SAFETY RECALL BULLETIN

NHTSA RECALL 23V193

AUTOCAR, LLC SAFETY RECALL ACX-2304

This Recall bulletin provides instructions regarding the relocation of the external fuse box and the installation of a debris shield.

Figure 1

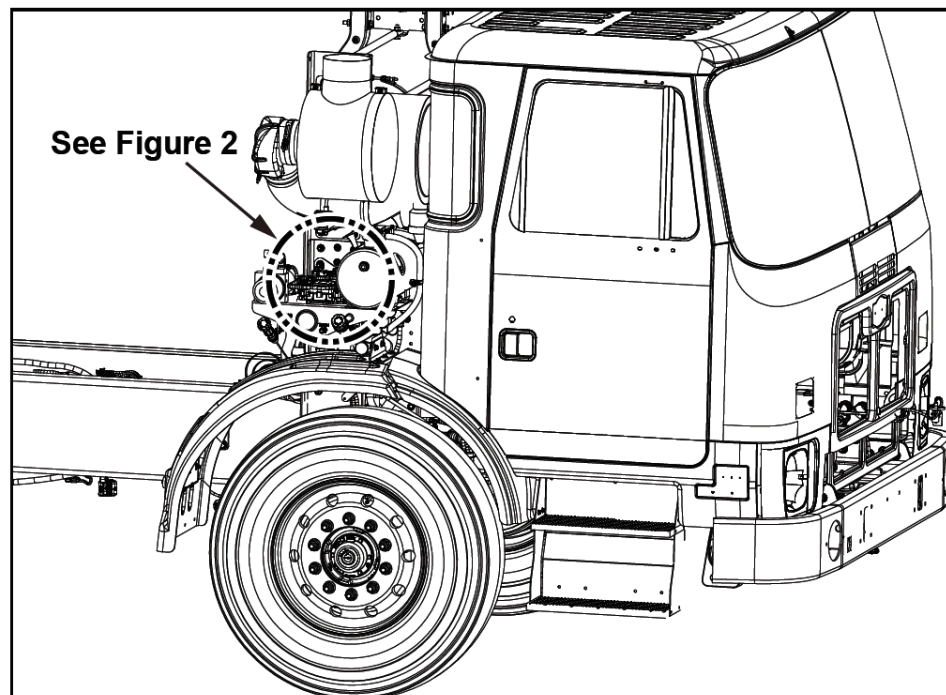
1. Follow all lockout/tagout procedures and verify the battery disconnect switch is in the “OFF” position. If the unit is not equipped with a battery disconnect switch, disconnect the battery cables beginning with the negative cables, followed by the positive cables.
2. Locate the external fuse box on the outboard side of the right upright (see Figure 1).

Figure 2

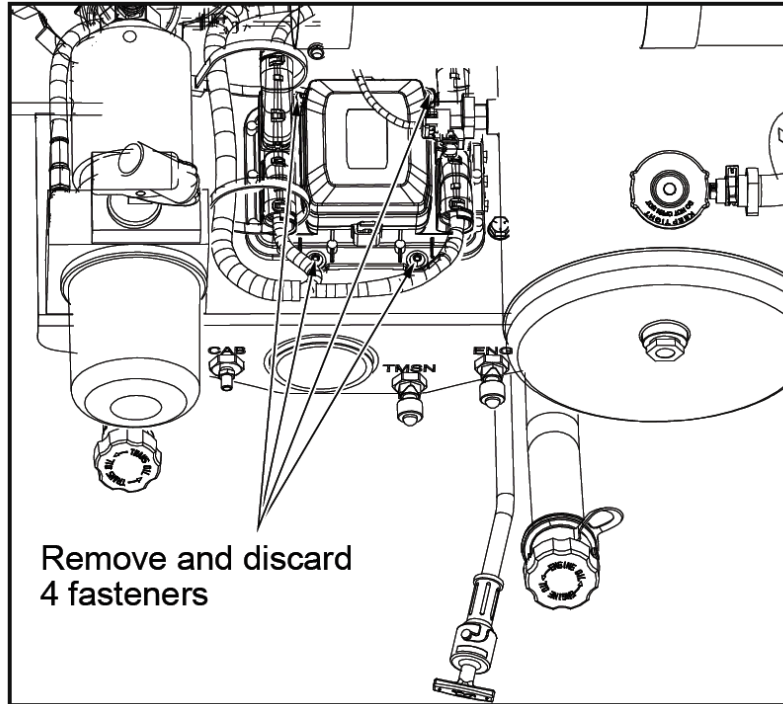
3. Locate the external fuse box, remove and discard the four mounting fasteners (see Figure 2).

Figure 3

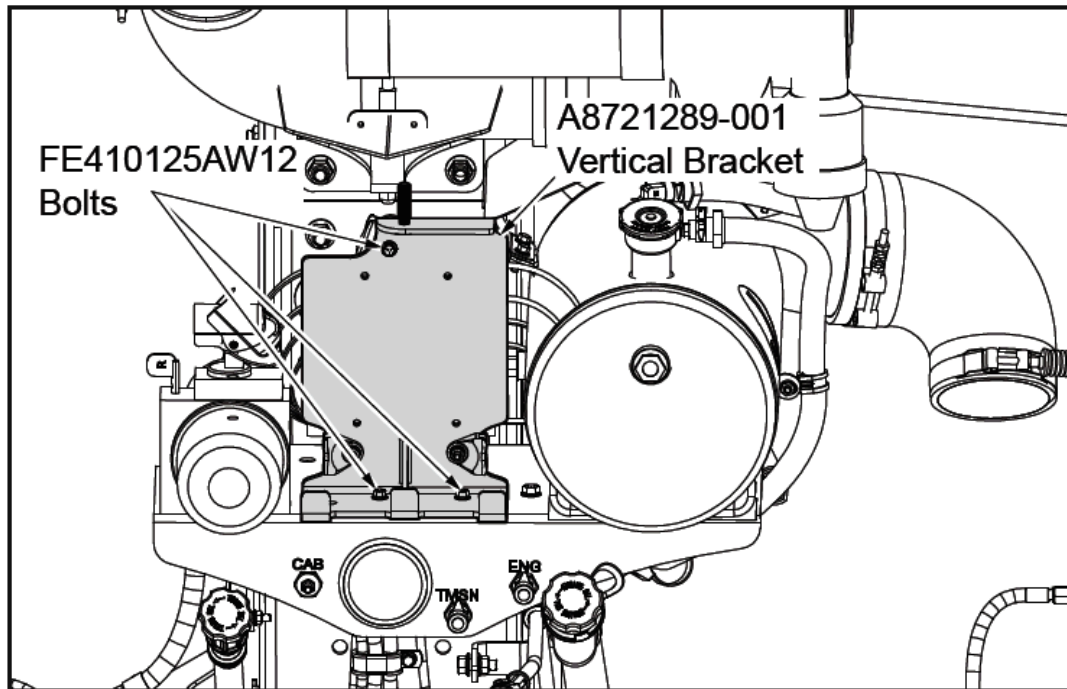
- Using three FE410125AW12 Bolts, install the A8721289-001 Vertical Bracket (see Figure 3).

Figure 4

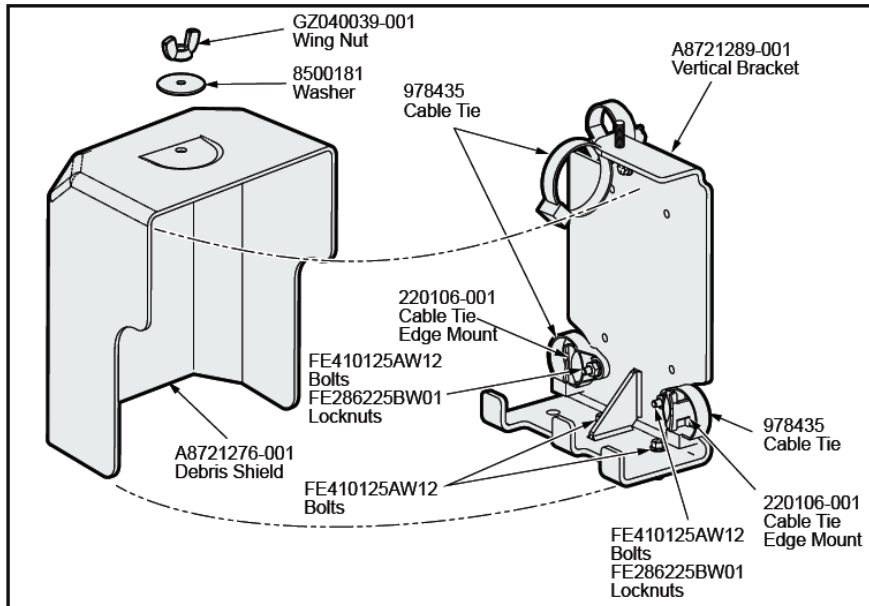
5. Install three 220106-001 Cable Tie Edge Mounts onto the Vertical Bracket and four 978435 Cable Ties (see *Figure 4*).
6. Install four FE410125AW12 Bolts and three FE286225BW01 Locknuts (see *Figure 4*).

Figure 5

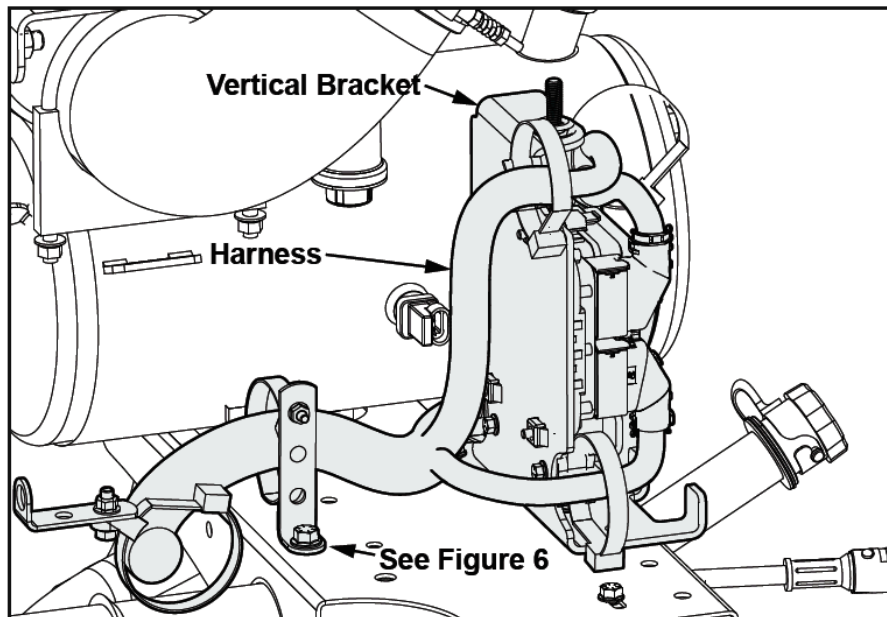
- Install the GZ220010-006 Three Hole Bracket and two FE410125AW12 Bolts. Install FE286225BW01 Locknut and GZ220044-001 Cable tie mount with 978435 Cable tie and FE410137AW12 Bolt. Route and secure harnesses as illustrated (see Figures 5 and 6).

Figure 7

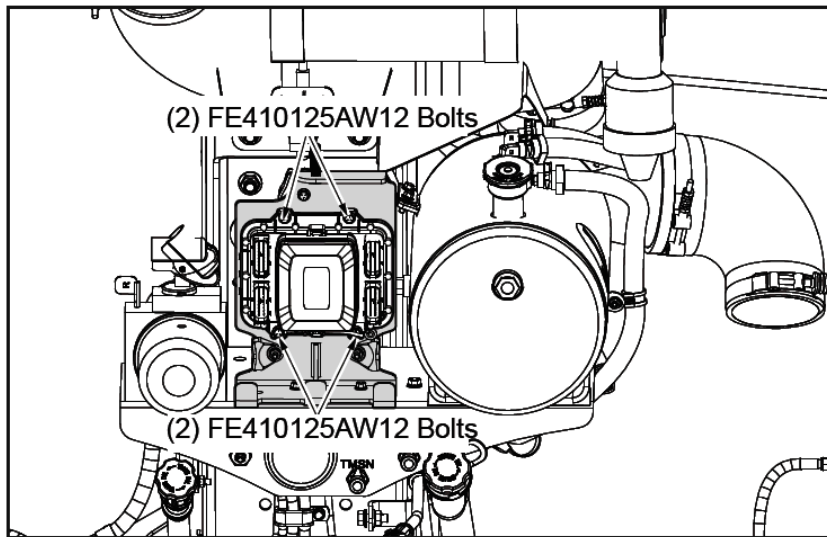
8. Using four FE410125AW12 Bolts, reinstall the FB3 Fuse Box (see *Figure 7*)
9. Install the new A8721276-001 Debris Shield, 8500181 Flat Washer and the GZ040039-001 Wing Nut (see *Figure 4*).

Figure 9

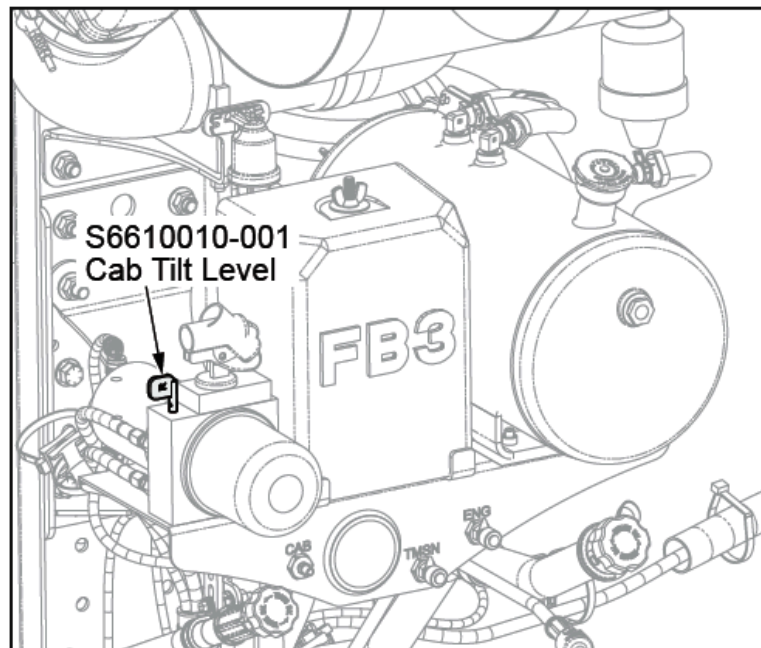
11. Install the 1" S6610010-001 Cab Tilt Lever (see Figure 9).
